Onondaga County Planning Board

MEETING AGENDA

Wednesday, August 5, 2026
11:00 AM

ONONDAGA COUNTY PLANNING BOARD STAFF REPORT AUGUST 05 2026 S-26-24

C2.1
SITE PLAN

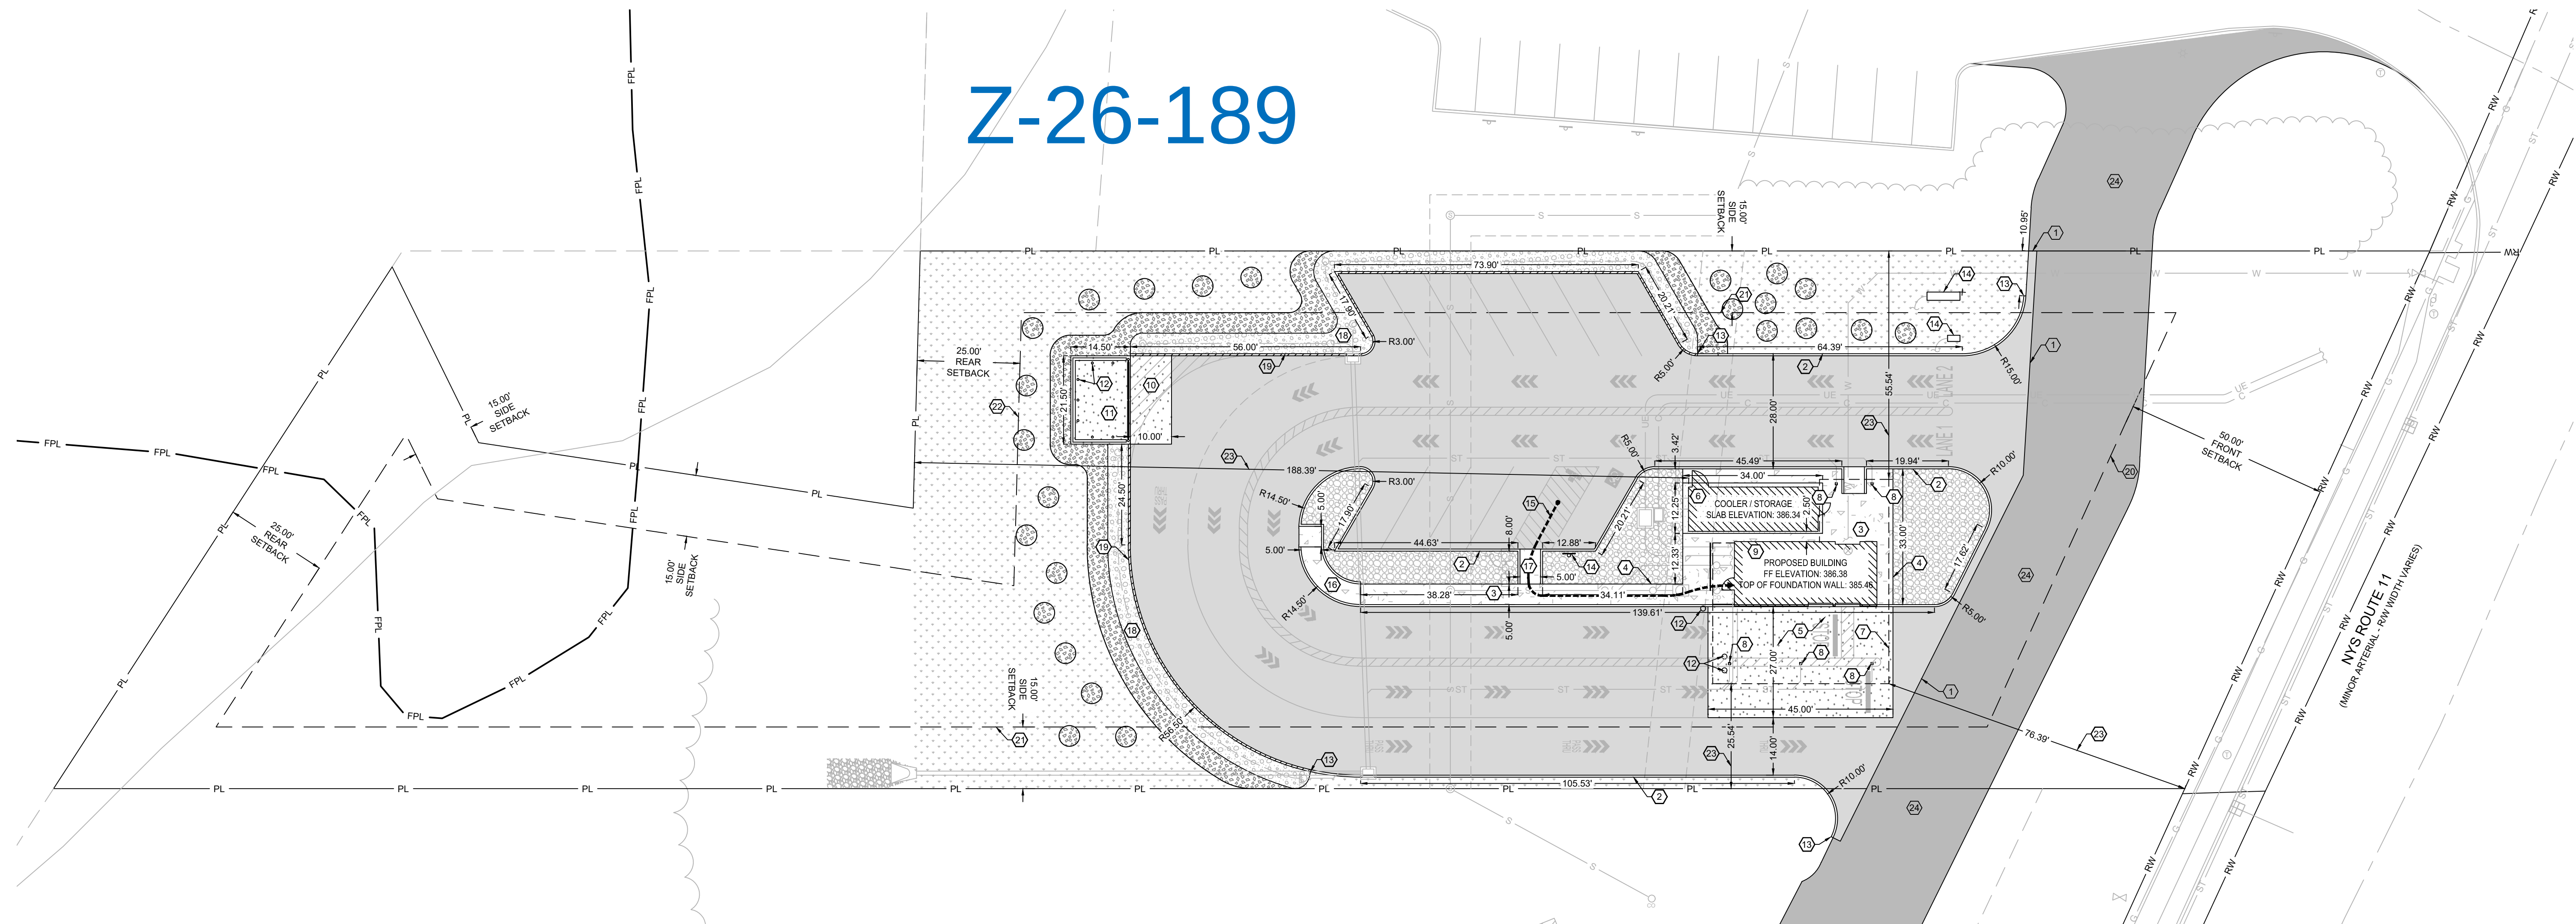
Access: Per the Conceptual Site Plan, the site will have one full-access driveway to East Taft Road at the eastern side of the road frontage and a right-in/right-out driveway at the western side of the subject area’s East Taft Road frontage.

Per the Conceptual Site Plan, Wheatley Road is to be abandoned and the northern portion which travels west to connect to Northern Boulevard will be converted to a driveway that connects the rear of the Byrne site to Northern Boulevard. It is unclear if this proposed driveway will also connect to the Future Pad Site.

Parking: Per the Conceptual Site Plan, 20 parking spaces will be provided along three sides of the retail building with an additional 19 spaces along the sides of the asphalt area in this location. An additional 8 tractor trailer spaces will be located in the northeast corner and adjacent to the diesel fueling station.

Stormwater: Per the Environmental Assessment Form (EAF) dated 6/23/26, 7 acres of the site will be disturbed by the proposed project and stormwater will be directed to the "County DOT roadside drainage system." Per the Conceptual Plan, the parcel currently surrounded by Wheatley Road will be the location of a Stormwater Management Area.

Landscaping: No plantings or landscaping are indicated on the plans.

Wetlands: GIS mapping shows significant areas of state and federal wetlands exist along Interstate 481 to the north, extending south and encroaching the northern half of the site, including NYSDEC regulated wetland CIC-17. Per the Conceptual Site Plan, it appears some wetlands boundaries include most of the building and fueling station area and additional wetland and its 100'-buffer are located north of the asphalt area.
